FUEL—VENTING TANK WHEN SERVICING CNG FUEL SYSTEM—SERVICE TIP—BI-FUEL VEHICLES ONLY	Article No. 00-8-5

FORD: 1996-2000 CONTOUR

Figure 1 - Article 00-8-5

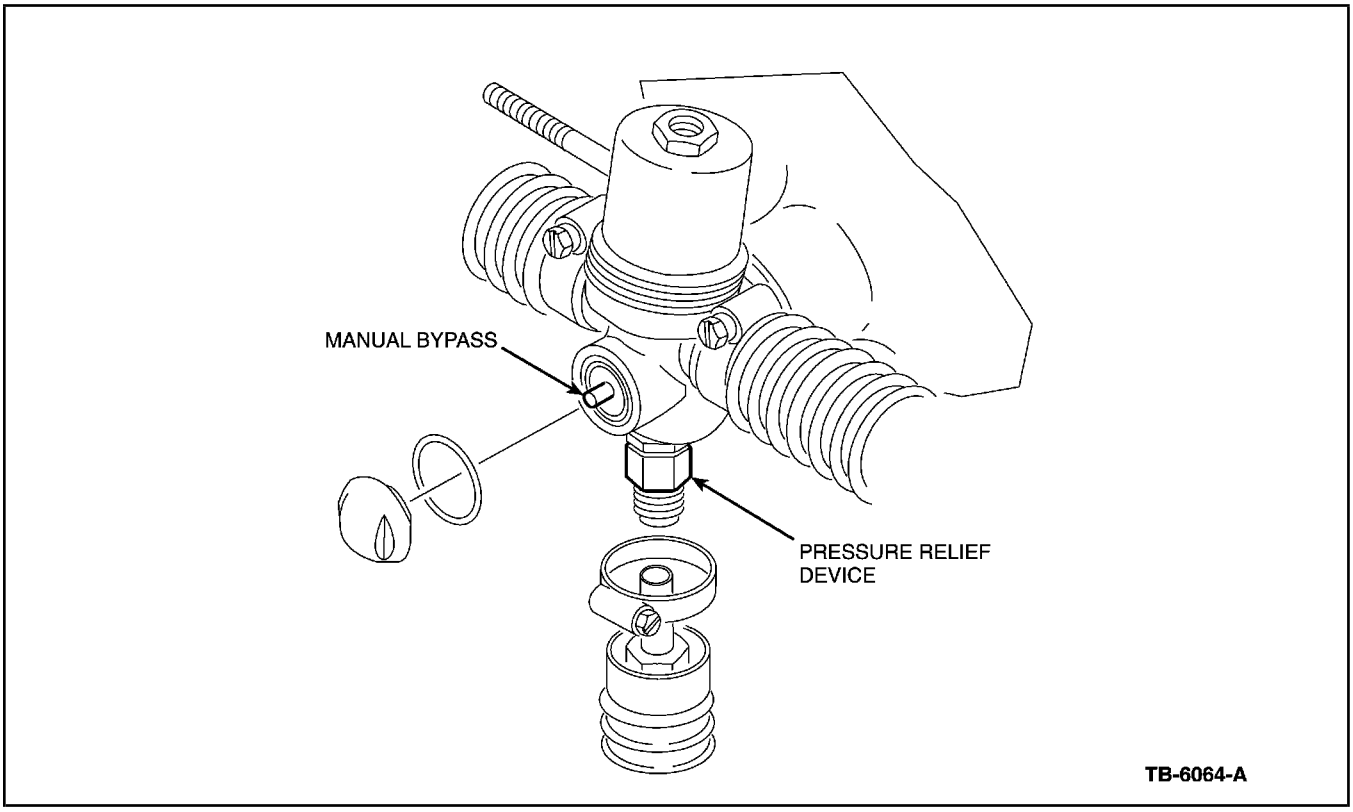
Due to an internal design change to the solenoid tank valve, the pressure release device (PRD)can no longer be removed from the tank valve without first venting the fuel tank.

When servicing the CNG fuel system, where bleeding the system or fuel system pressure release is required, always use the manual bypass to close the solenoid tank valve (Figure 1).

When closing the solenoid tank valve (by using the manual bypass), all lines and fittings can be serviced with the exception of the PRD where tank pressure is still present (Figure 1).

Before removing any PRD from a tank valve, the CNG fuel tank MUST be fully vented.

DO NOT REMOVE THE PRD AT ANY TIME UNTIL THE TANK IS FULLY VENTED OF ALL PRESSURE. THE TANK SHOULD NEVER BE LEFT UNATTENDED WITH THE MANUAL BYPASS IN THE CLOSED POSITION. THE NATURAL GAS FUEL SUPPLY IS PRESSURIZED TO 3000 PSIG. REMOVAL OF COMPONENTS WITHOUT PRESSURE RELIEF OR VENTING OF THE CNG TANK CAN CAUSE NATURAL GAS TO ESCAPE INTO THE AIR AND CAUSE INJURY OR DEATH.
